Engineering Review

EPC Planning & Community  
Development Department

**FINAL DRAINAGE REPORT  
FOR  
RETREAT AT TIMBERRIDGE  
FILING NO. 2**

PCD-ENGINEERING REVIEW COMMENTS  
IN BLUE BOXES WITH BLUE TEXT

## HEC-RAS CALCULATIONS

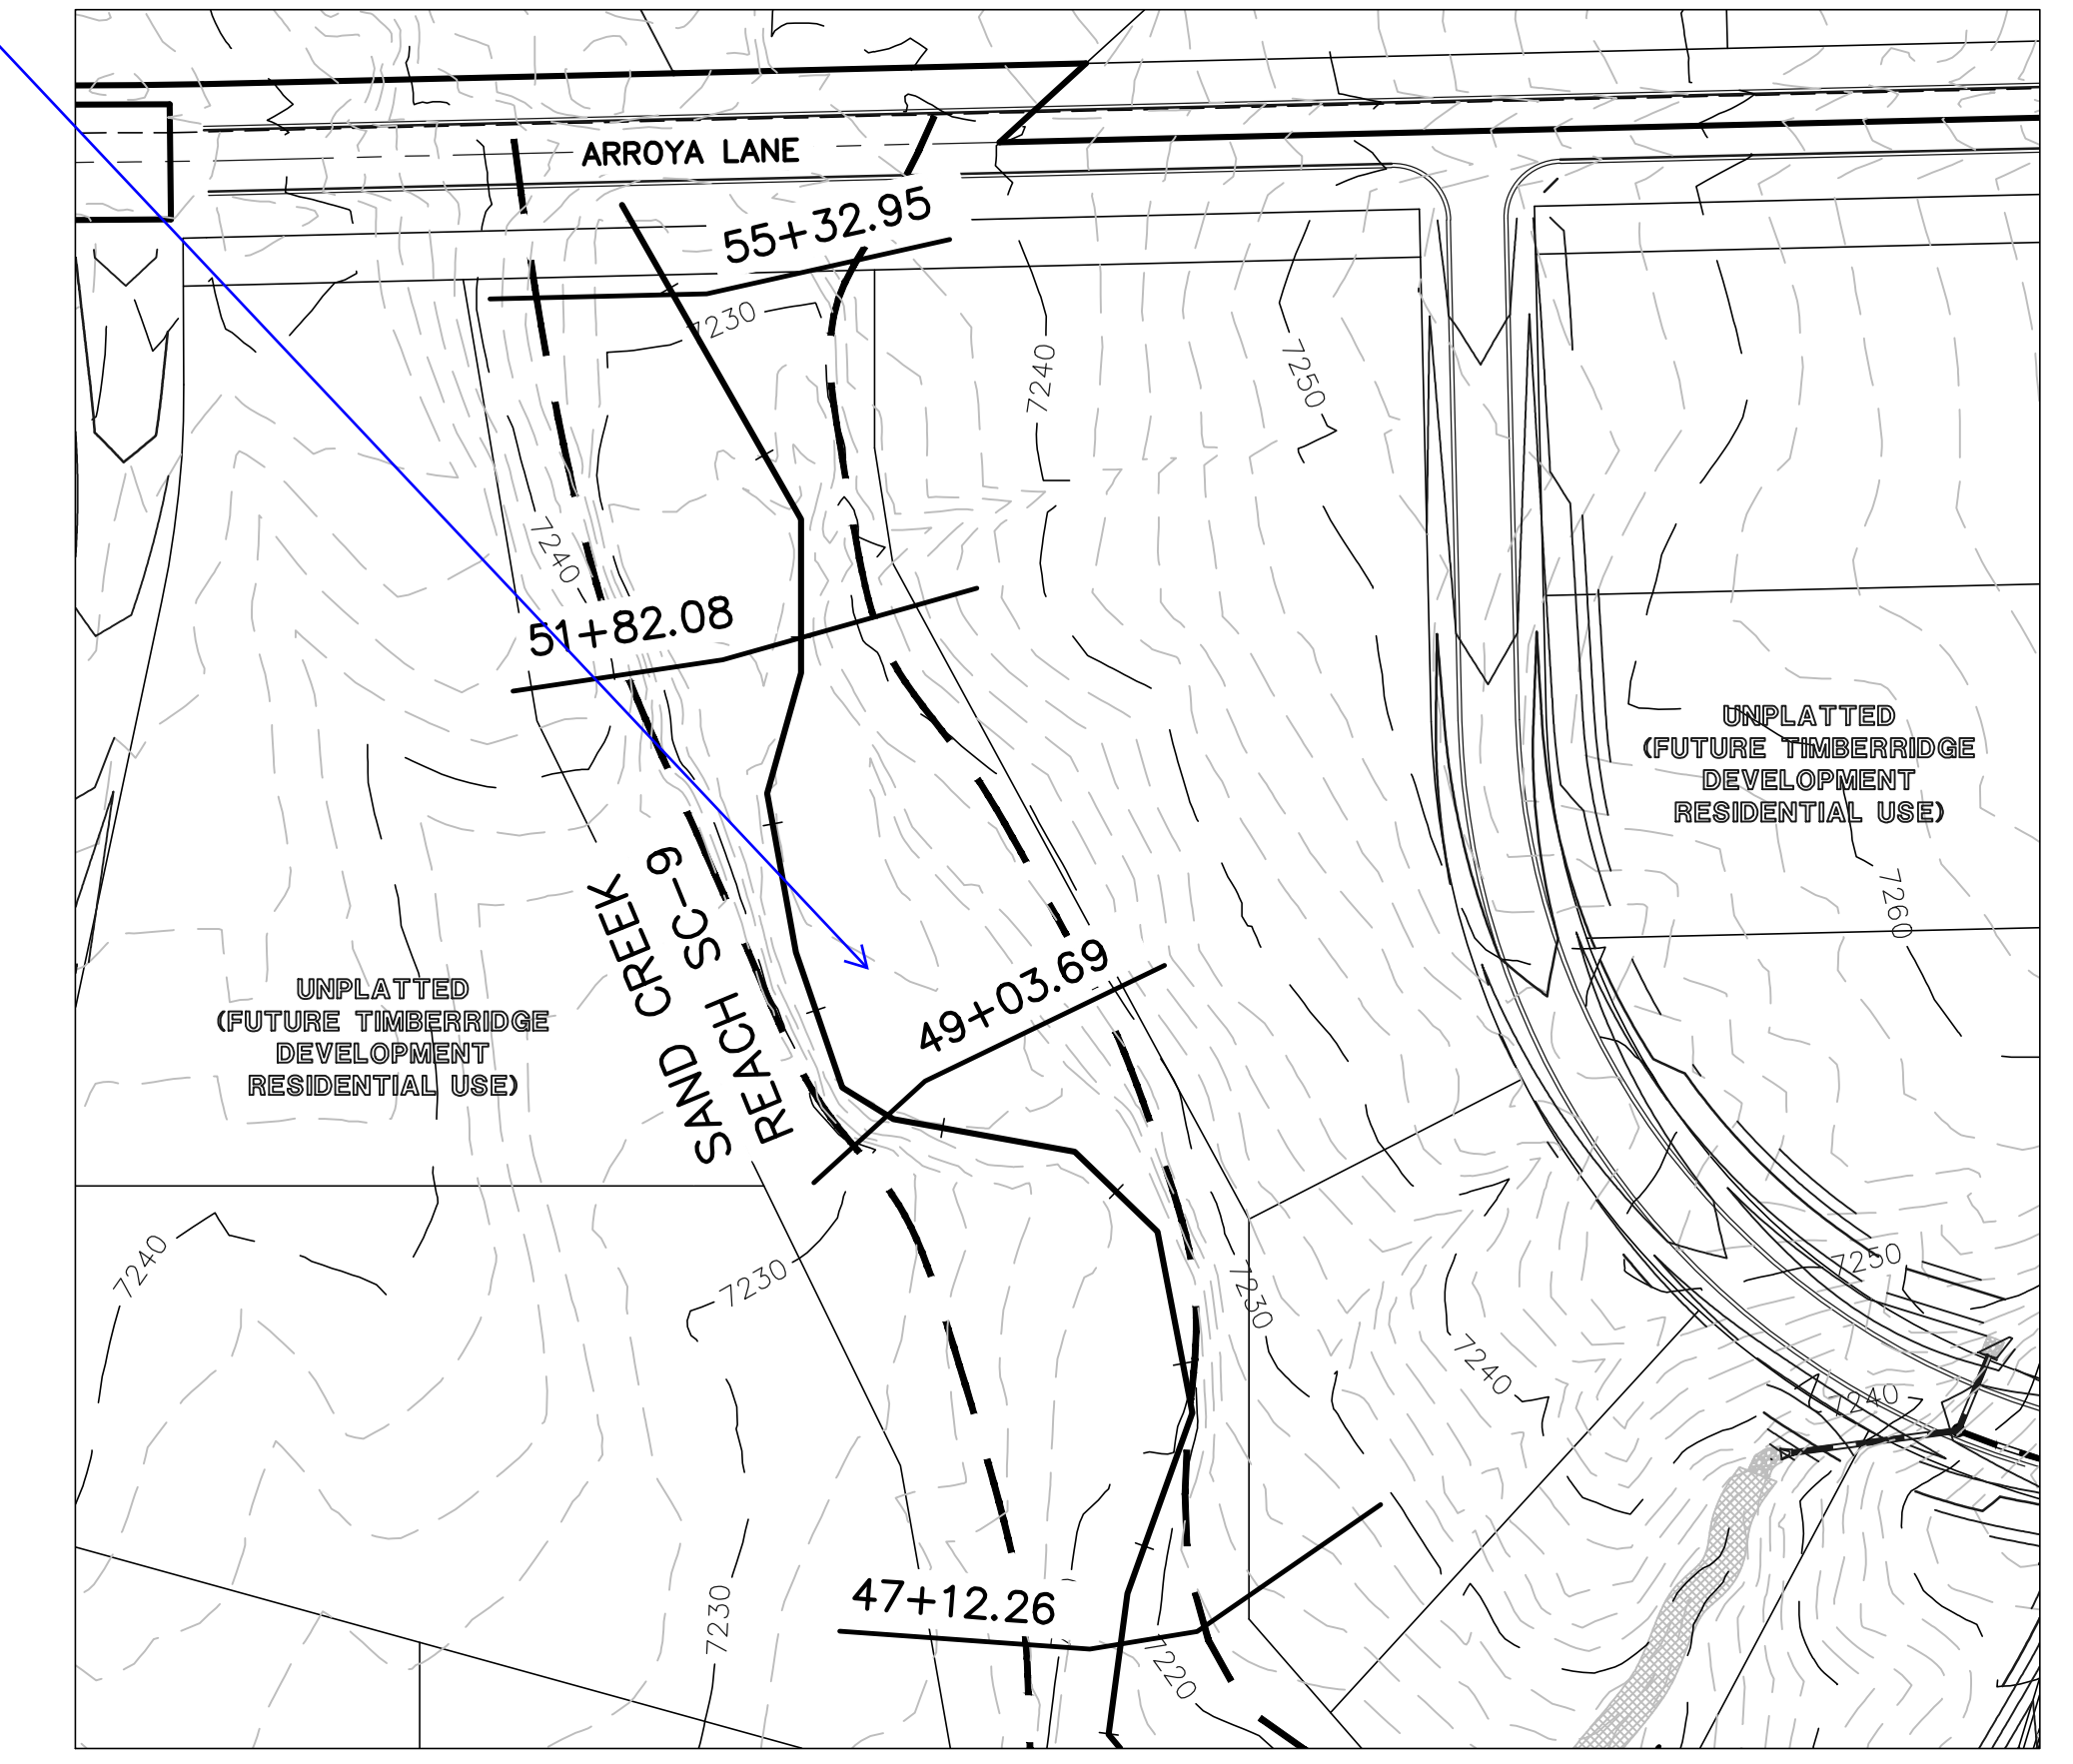
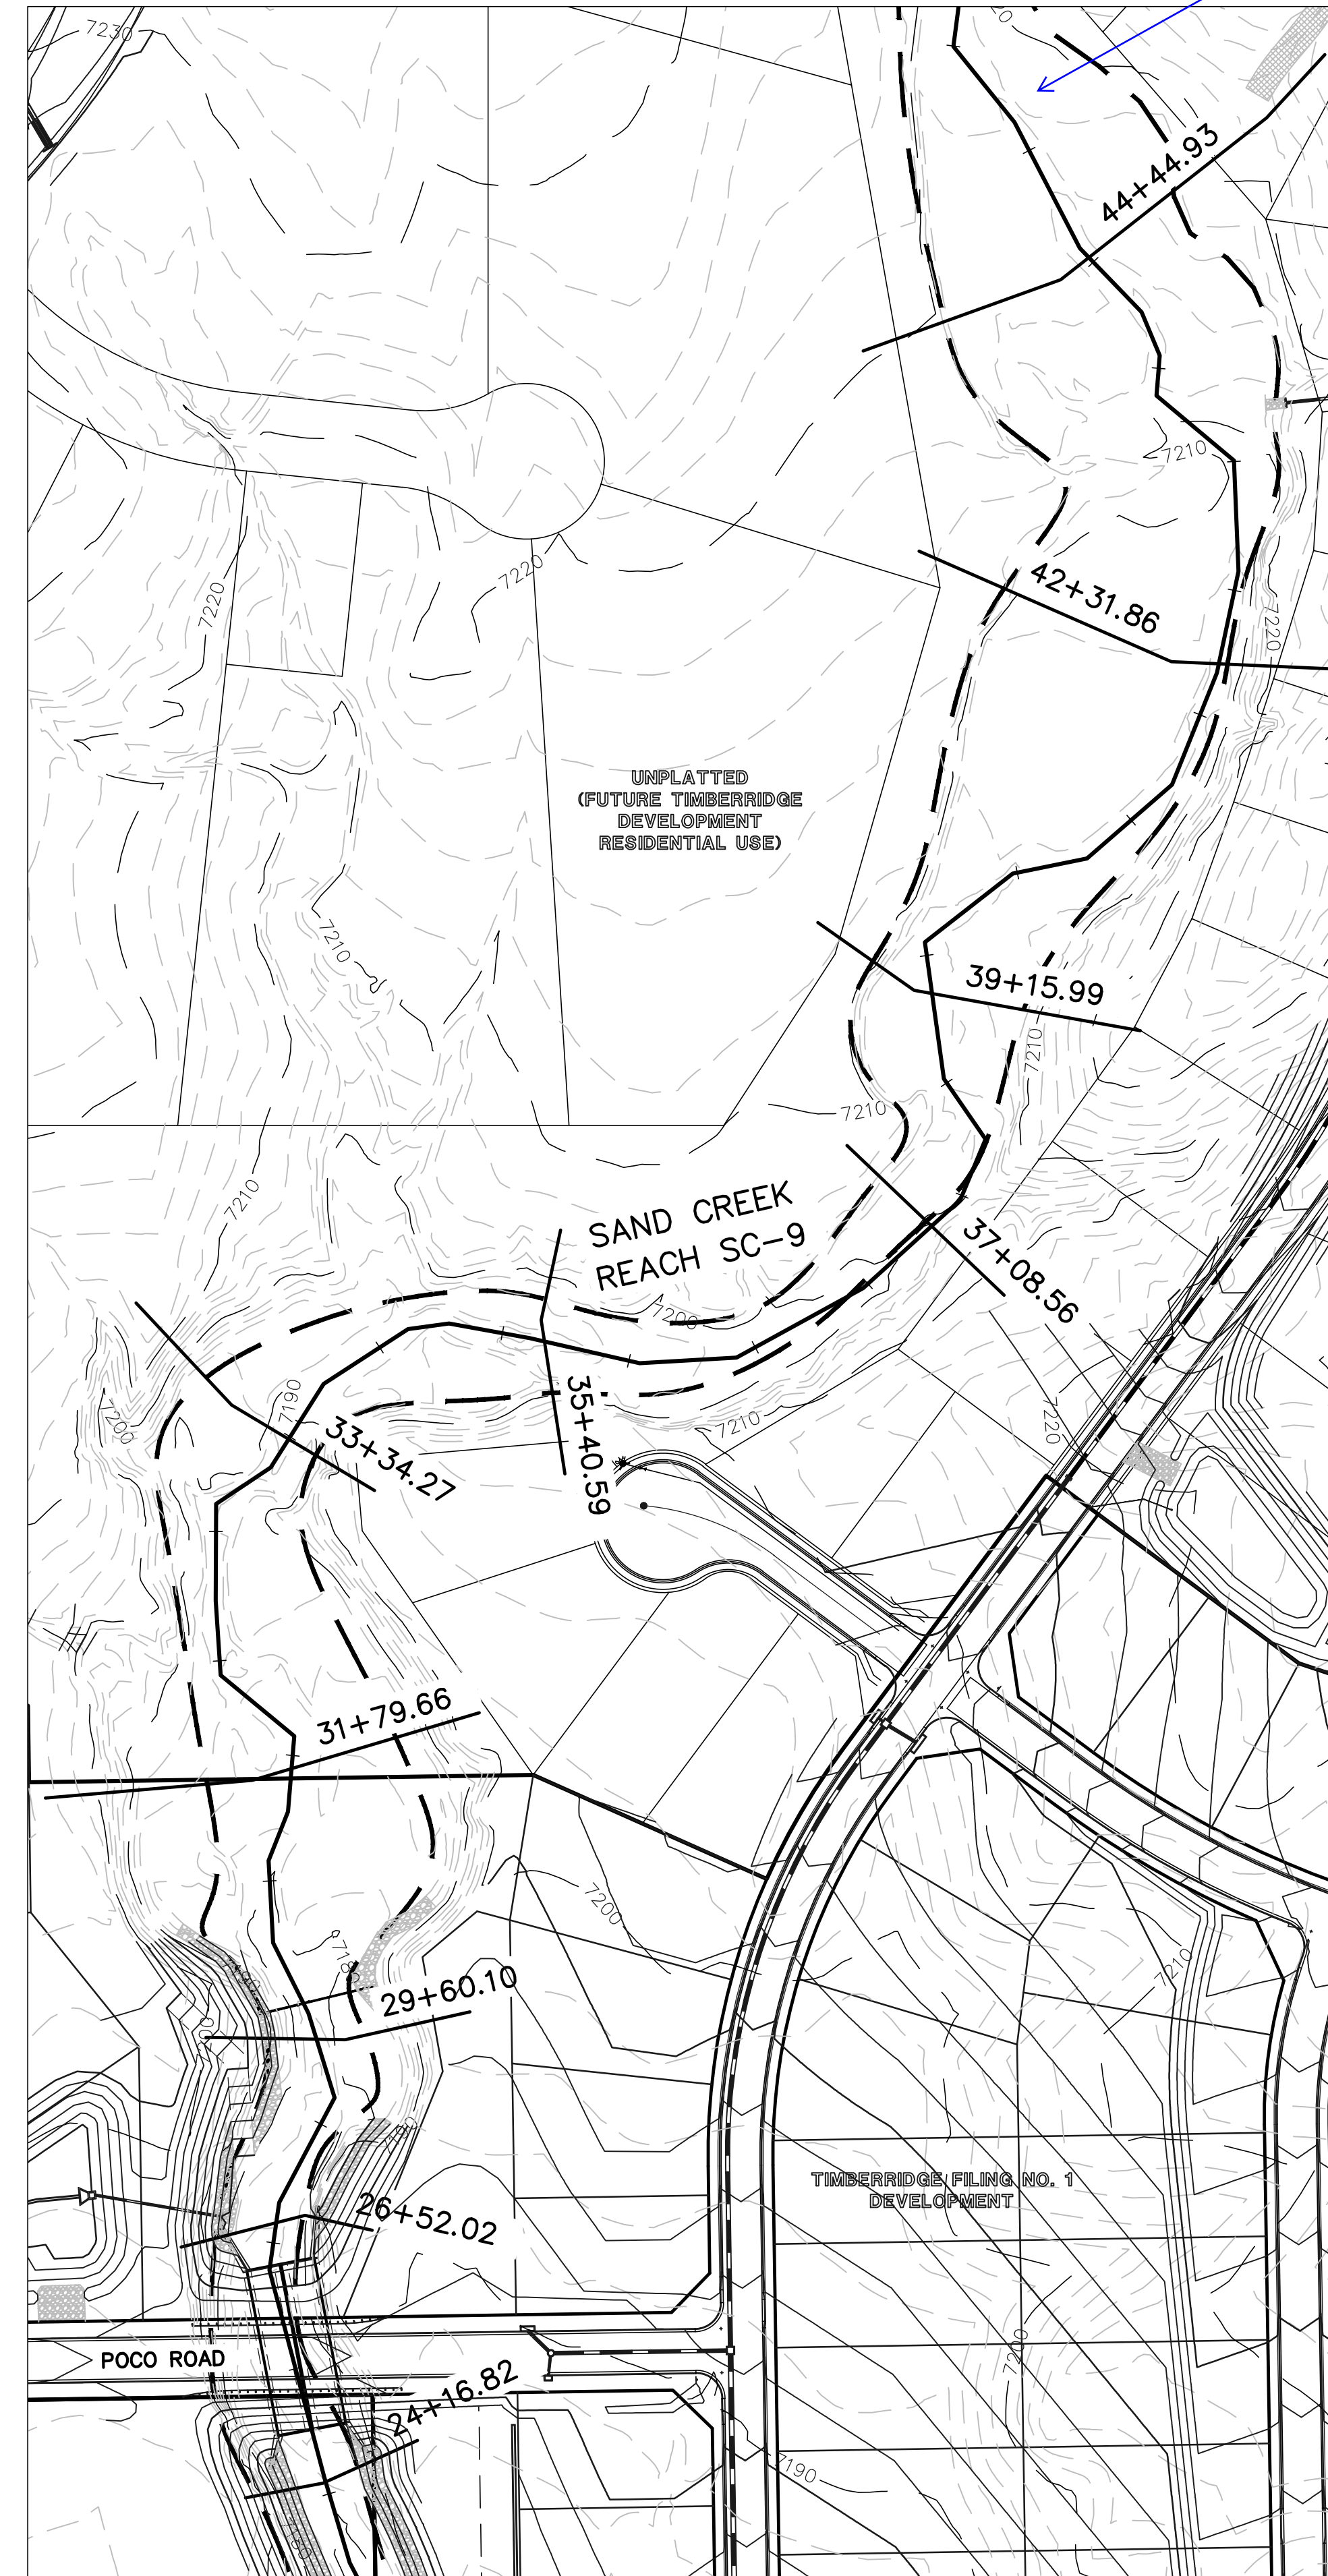
Please add the FEMA water surface elevation lines
